**TOWN OF NEWBURGH  
PLANNING BOARD  
TECHNICAL REVIEW COMMENTS**

**PROJECT NAME:** 14 MARINO DRIVE (AFONSO)  
**PROJECT NO.:** 22-11  
**PROJECT LOCATION:** SECTION 2, BLOCK 1, LOT 16 & 23.2  
**REVIEW DATE:** 1 JULY 2022  
**MEETING DATE:** 7 JULY 2022  
**PROJECT REPRESENTATIVE:** DOCE ASSOCIATES

RE: Two Lot Subdivision and Lot Line Change Plan  
Lands of Afonso - Marino Drive  
Section 2 Block 1 Lots 16 and 23.2  
Application No. 22-11

**TWO LOT SUBDIVISION AND LOT LINE CHANGE PLAN**  
FOR  
**JOSEPH P. AND MARIA S. AFONSO**  
14 MARINO DRIVE, TOWN OF NEWBURGH  
ORANGE COUNTY, NEW YORK  
DATE: APRIL 20, 2022 SCALE: 1 IN. = 60 FT.  
TAX PARCEL SECTION 2 BLOCK 1 LOTS 16 & 23.2

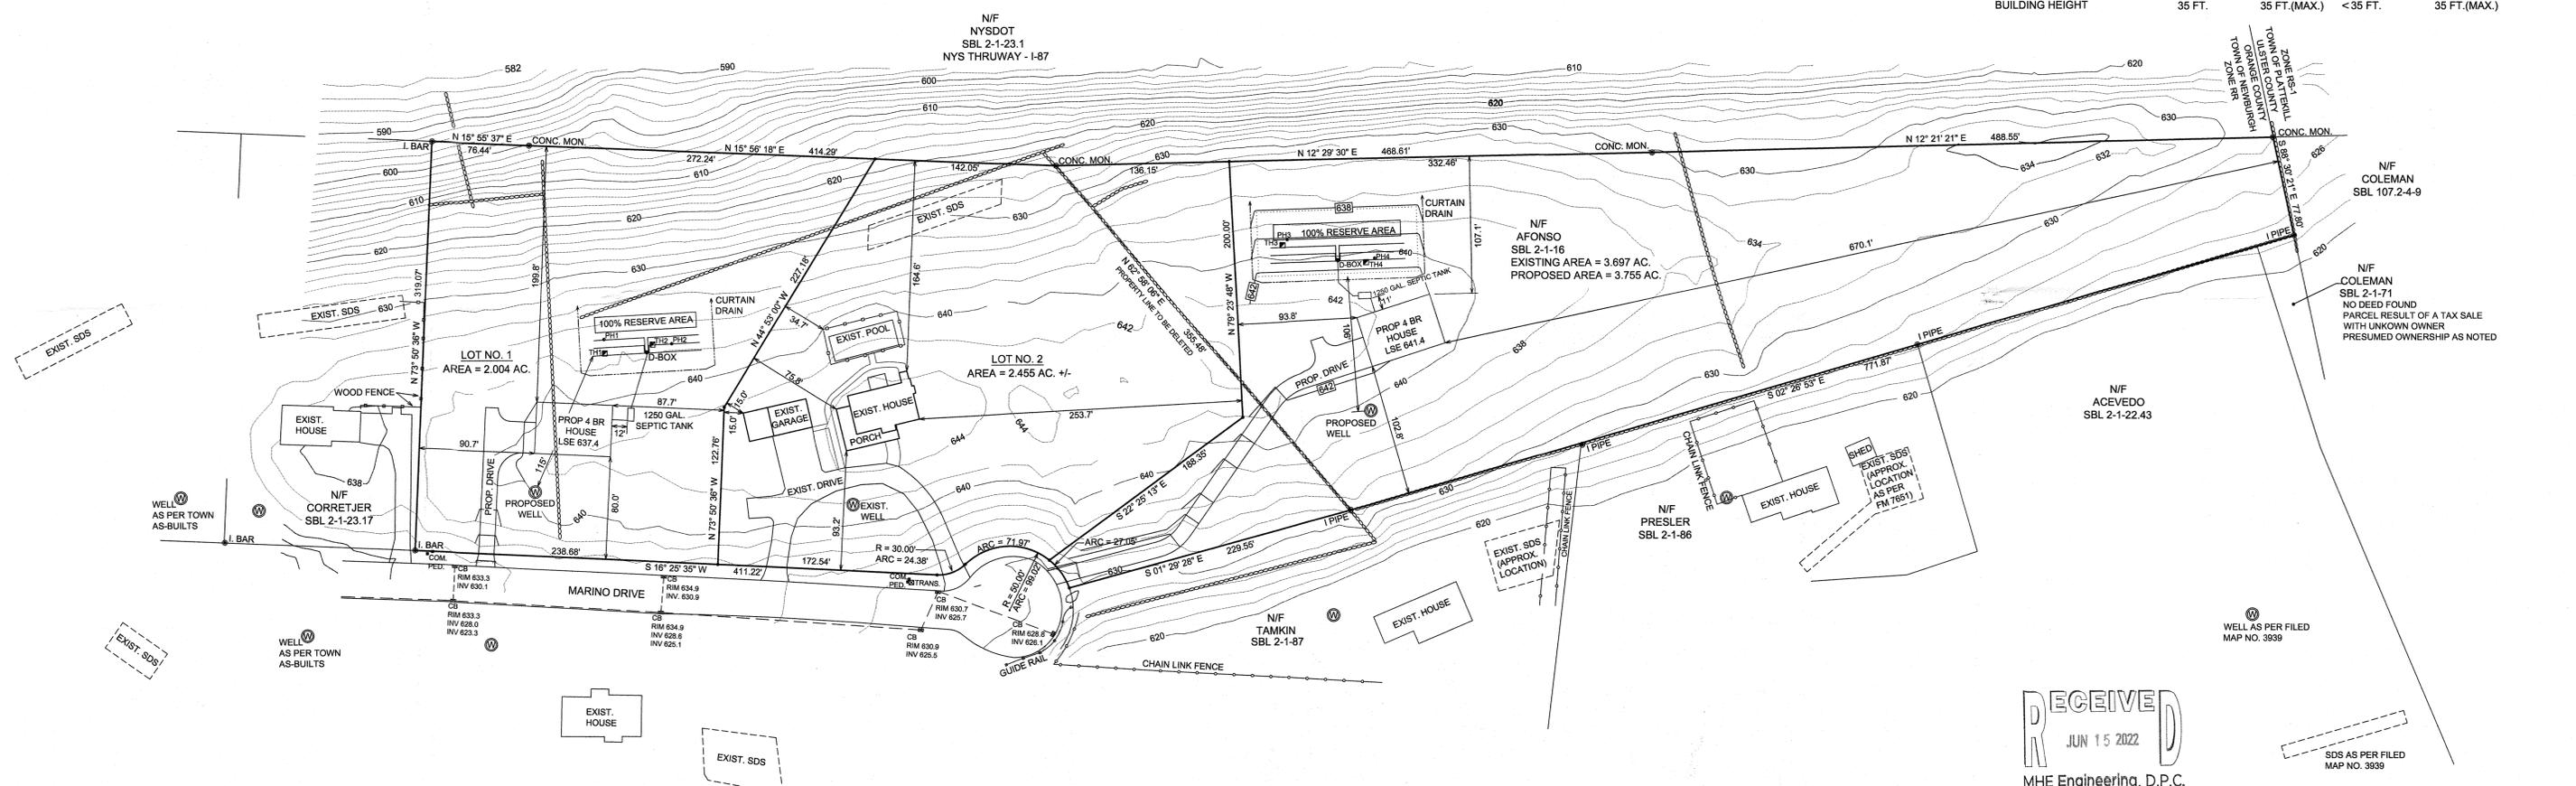
1. By letter dated June 6, 2022, the Orange County Department of Planning has reviewed the plan and has no advisory comments.
2. The bulk table (sheet 1) has been revised to remove the +/- references.
3. Tax Lot 87 does not have a driveway off of the Marino Drive cul-de-sac. Access to this lot is from Coventry Lane.
4. By a memo dated May 24, 2022, Mark Hall has indicated he has reviewed the plans and has no comment.
5. The bulk requirement setbacks have been labelled on each lot.
6. The chart for the proposed sewage system designs is located on sheet 1.
7. The adjoiner mailings were sent out May 31, 2022.
